Re: Response to Notice of Deficiency regarding CQA Certification Report
for the Garland County Cedar Glades Class 4 Landfill, Hot Springs, Arkansas
Permit No. 0300-S4; AFIN: 26-00405
Ref ID: 0300-S4_2024 Phase 3, Cell 1 CQA Certification Report_20251213.pdf
Terracon Project No. 35247264

Additional Figures Showing
Property Boundary, Landfill Boundary and
Constructed Cell Boundary

PHASE 3 - CELL 1 & PARTIAL CLOSURE
GARLAND COUNTY CEDAR GLADES CLASS 4 LANDFILL
HOT SPRINGS, ARKANSAS

FIGURE 1

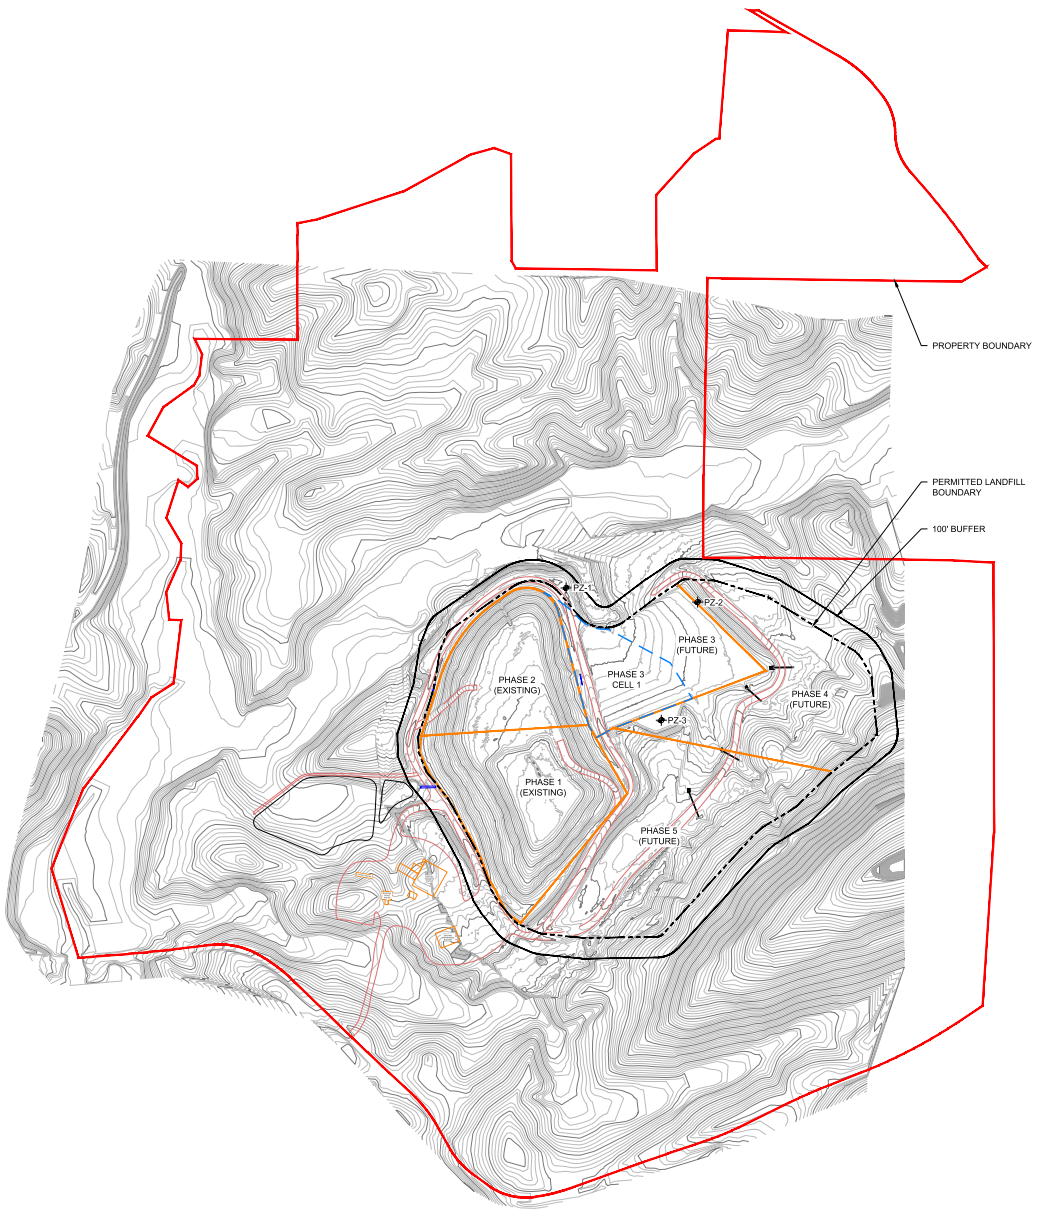
DEQ Comment: **1.a.1.i. Layout of prepared areas in relation to permitted boundaries: The site boundary is not shown on any map. Please revise the CQA certification report to provide this information.**

DEQ Comment: **1.a.1.ii. Item 1(b) Property boundaries and/or corners: Similar to the item above, the boundaries of the site and all the future cells are not shown. Please revise the CQA certification report to provide this information.**

DEQ Comment: **1.a.1.iv. Item 1(g) A key map showing the location of the construction related to the permitted design, along with an identification of areas previously constructed and areas yet to be constructed: The key map does not show the future cells to be constructed. Please revise the CQA certification report to provide this information.**

Response: Revised and additional figures that illustrate the permitted boundary and property boundary have been added to the certification report. Figure 1A in **Attachment A** shows the property boundary, landfill waste boundary and the Phase 3, Cell 1 boundary. Figure 1B (both with and without the background aerial image) in **Attachment A** shows the property boundary, landfill waste boundary, 100’ buffer zone boundary and the Phase 3, Cell 1 boundary in relation to the completed and future cell areas.

Response: Figure 1B (both with and without the background aerial image) in **Attachment A** shows the property boundary, landfill waste boundary, 100’ buffer zone boundary and the Phase 3, Cell 1 boundary in relation to the completed and future cell areas.

Response: Please see Figure 1B in **Attachment A**.

FIGURE 2A

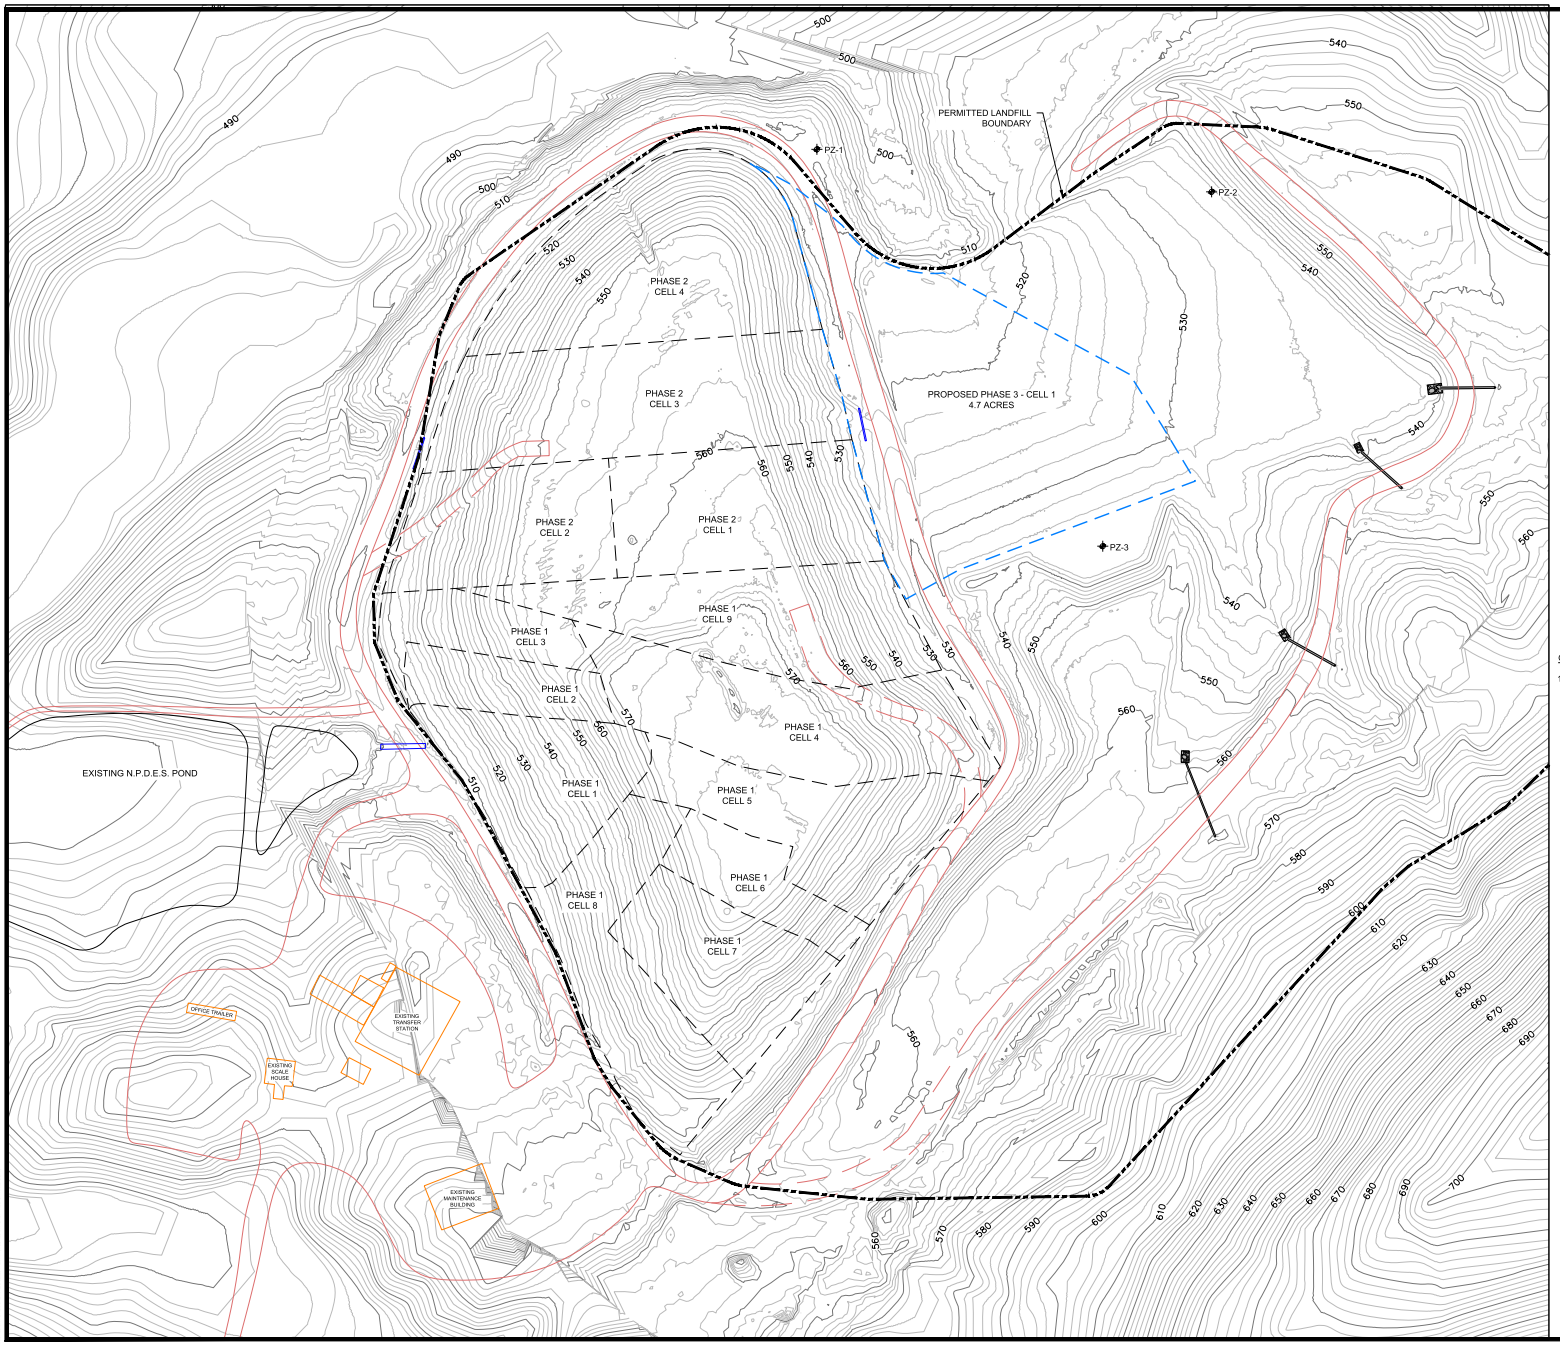
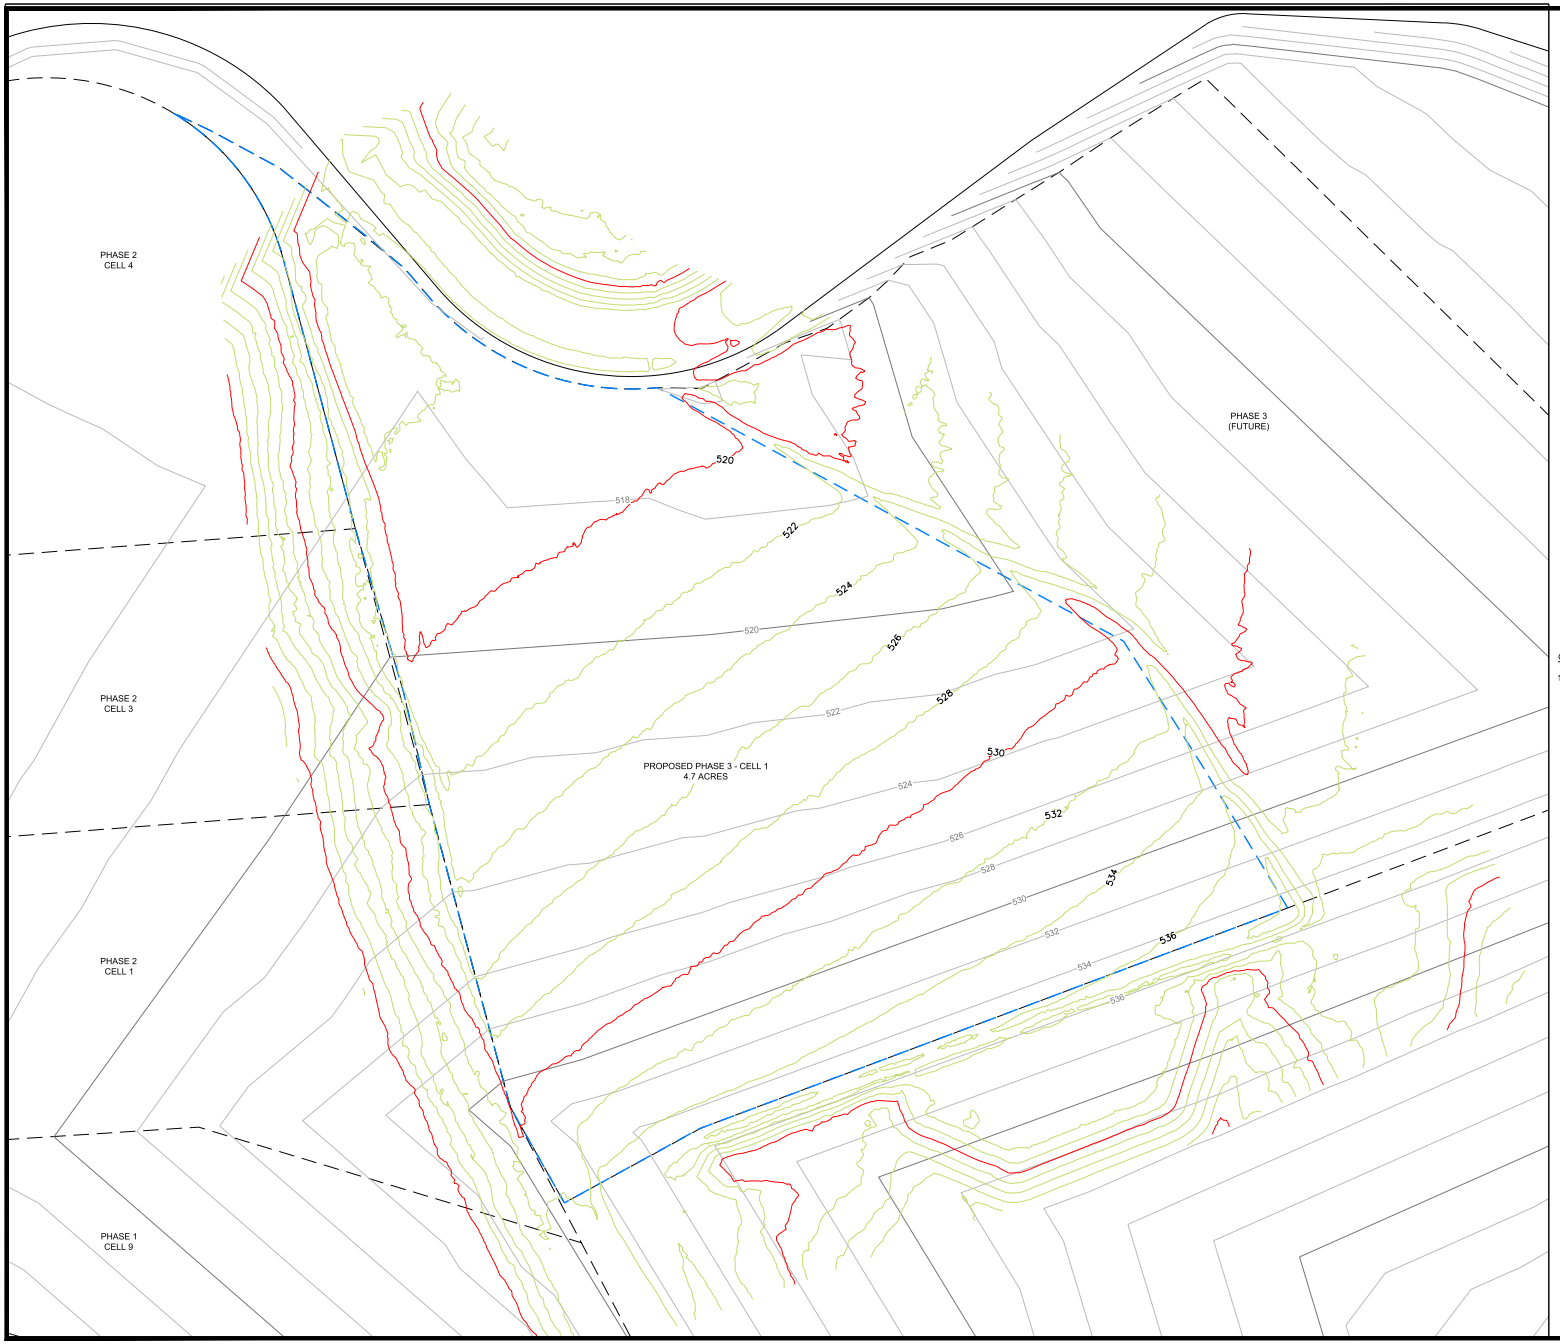
DEQ Comment: **1.a.1.iii. Item 1(c) Monitoring wells and piezometers (if scale permits): These items are not depicted on the figures, please add these items or clarify that scale does not permit them to appear on the figures. Please revise the CQA certification report to provide this information.**

Response: Please see PZ-1, 2 and 3 in Figure 2 in **Attachment A**.

DRAWING 1

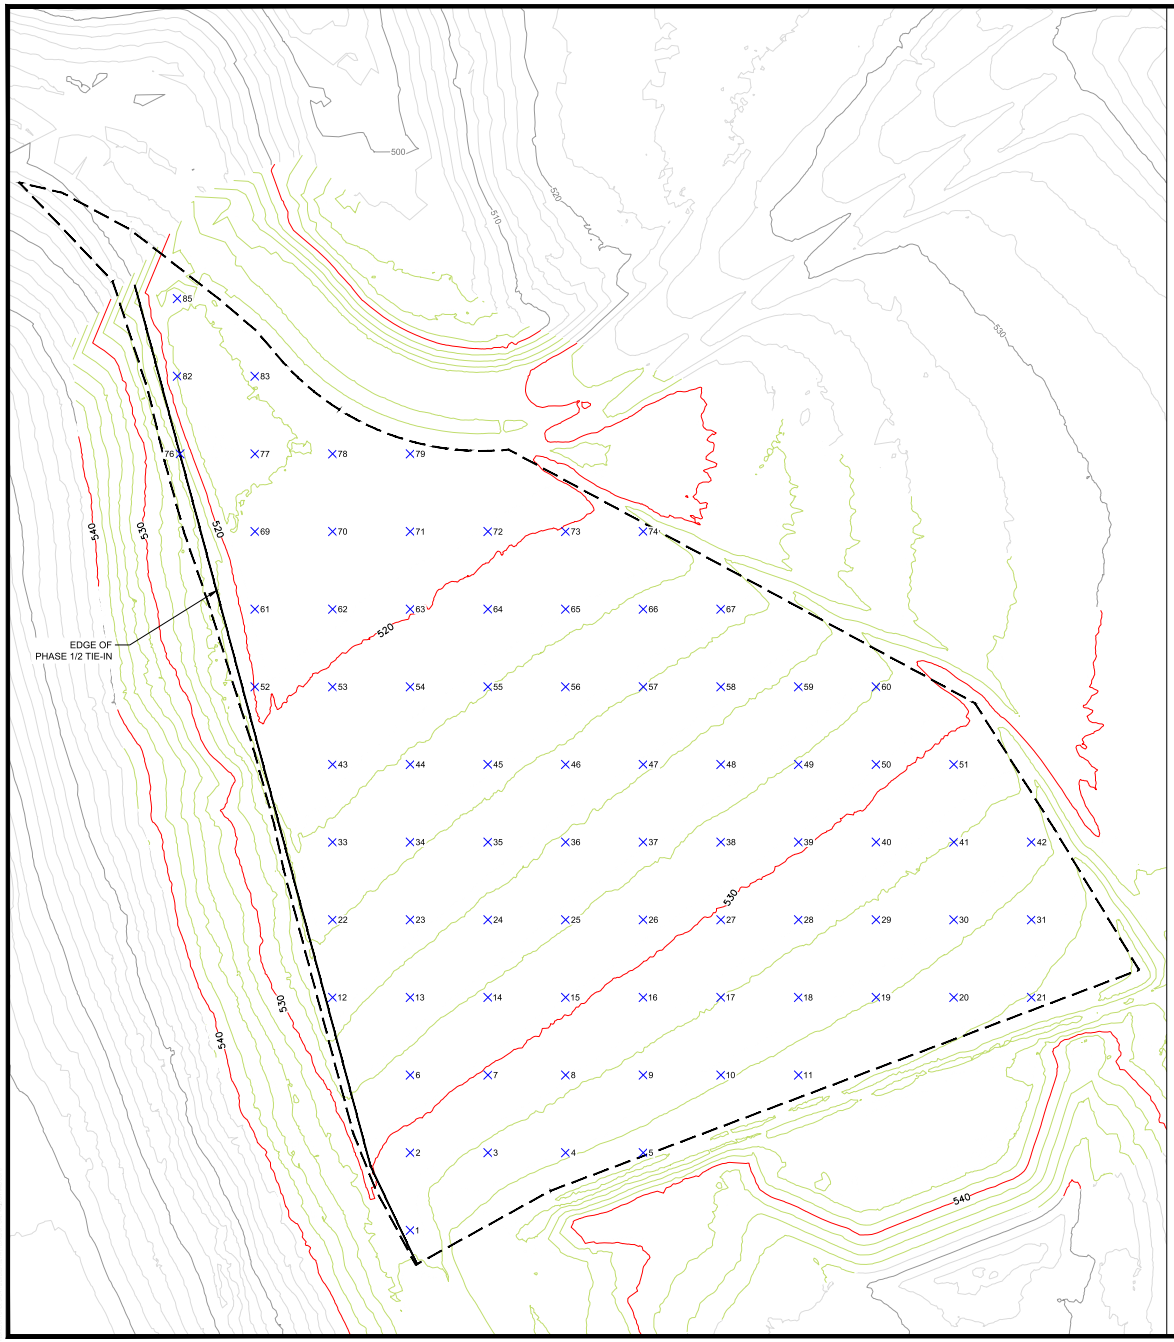
DEQ Comment: **1.b.2.i. Item 2(a) Prepared Subgrade plan: There are two sets of contour lines in Drawing 1 (one for the as-built subgrade and one for the as-built compacted clay liner). The legend uses the same lines style for two different items. Please provide a revised drawing to correct this issue.**

Response: Please see the revised Drawing 1 in **Attachment A**.
